Answer to Anonymous Referee #1

Interactive comment on “Physically based approaches incorporating evaporation for early warning predictions of rainfall-induced landslides” by Alfredo Reder et al.

Physically based approaches incorporating evaporation for early warning predictions of rainfall-induced landslides

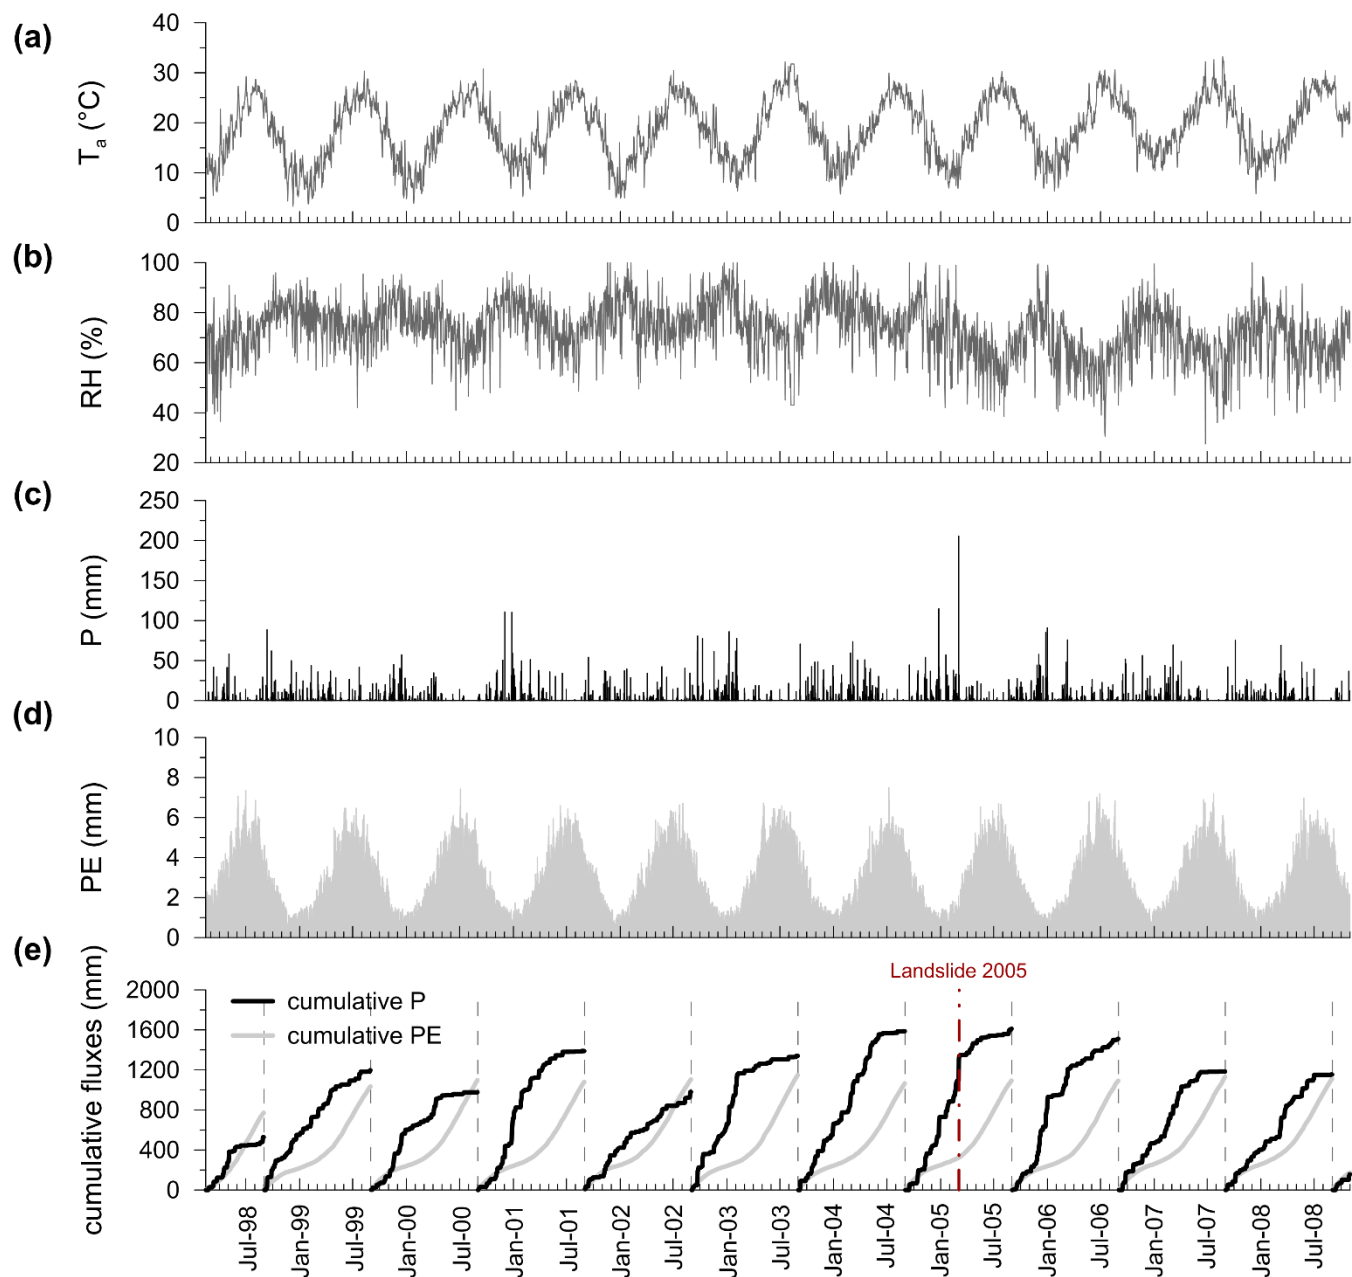
8) Page 3 line 20: can you spell the hydrological variables? Are the data the same used in Pagano et al., 2010?

We have indicated the hydrological variables reported in Figure 3; we have specified

that only precipitation is reported and used in Pagano et al. (2010) (Page 3 line 31-32 Page 4 line 1)

Figure 9: Calibration of model parameters: (a) experimental point at the depths of 15 and 70 cm versus fitting water retention curve; (b) experimental point versus fitting thermal conductivity function; (c) volumetric specific heat function

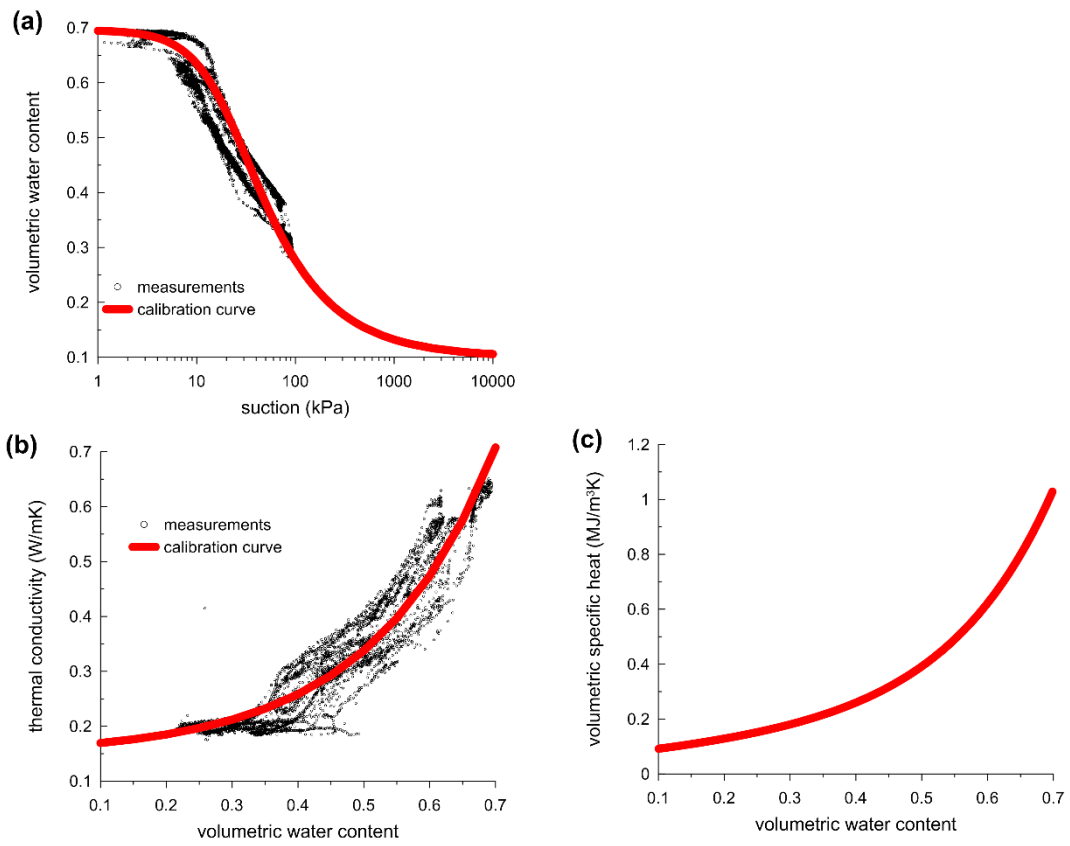
ii) effect of the hysteresis which is evident in the physical model data (Fig. 9- a);

17) Figure 15-c shows that the models tend to behave differently starting from around 10000 KPa. How often the soils experiment those value? Looking at the Figure 9-a the soils had suction values between 1 and 100 KPa and correctly the authors extend the soil water retention curve up to 1000 KPa. However the latter is lower than the 10000 KPa where the models tends to differ (Figure 15-a). Can the Authors comment on this point?

23) Figure 10 could be a sub-figure of Figure 9.

The hysteresis has been neglected in the present study by assuming a unique soil-water characteristic curve fitting all the available observations on calibration time span; the accuracy loss of the prediction due to neglecting hysteresis is at present topic of new researches (Page 10 line 3-5; Page 15 line 1-3).

The soil cover usually experiences such values only in the shallower layers during the dry season (see for example Wilson et al., 1994; 1997); nevertheless, the differences between the two approaches are not related in differences in SWCC but, as reported in the text, mainly to reference soil depth from which water is simulated to be extracted according the two interpretative approaches. (Page 11 line 10-14). We have also added a comment for SWCC (Page 8 line 15-17) and modified Figure 9(a) extrapolating data up to 10000kPa.

We have merged Figure 10 with Figure 9. Figure 10 is now Figure 9c.

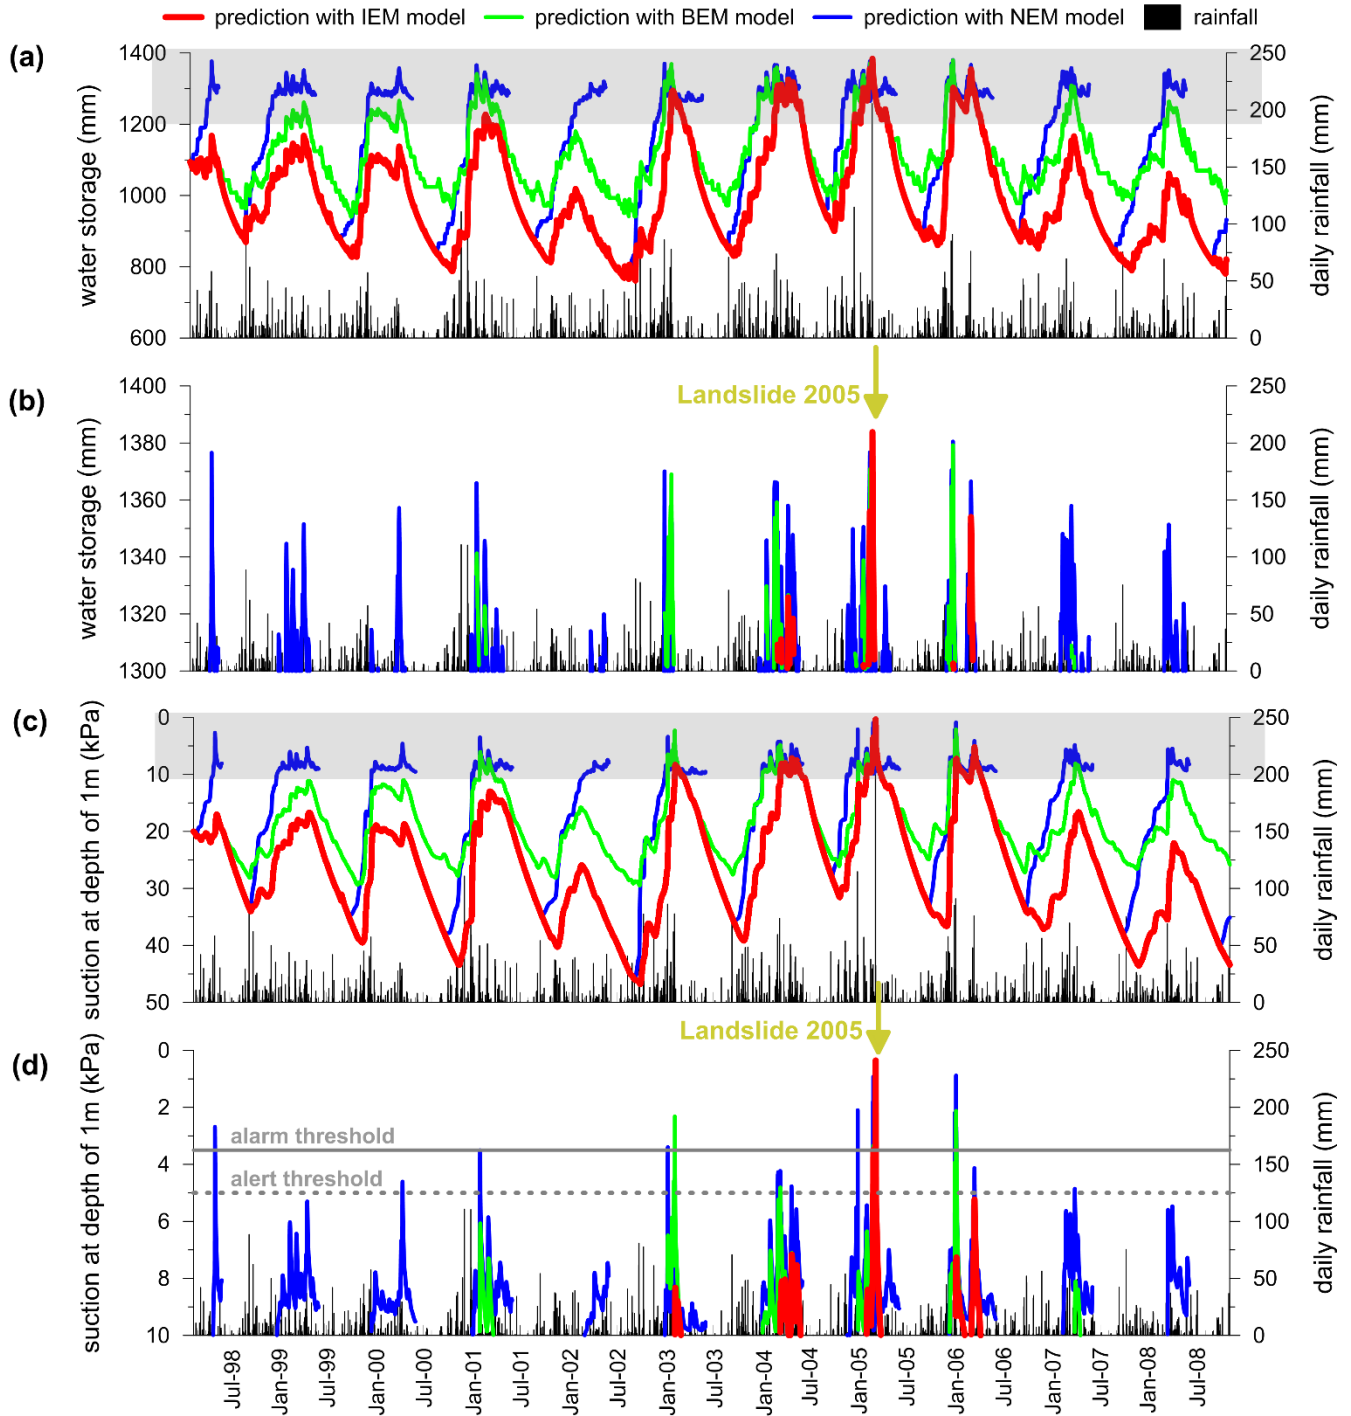
20) Please include the NEM model results in Figures 16 and 17 in order to have all the model results in the same figures.

As suggested also by Reviewer 2, we have merged Figure 15, 16 and 17 in one Figure (see Figure 15).
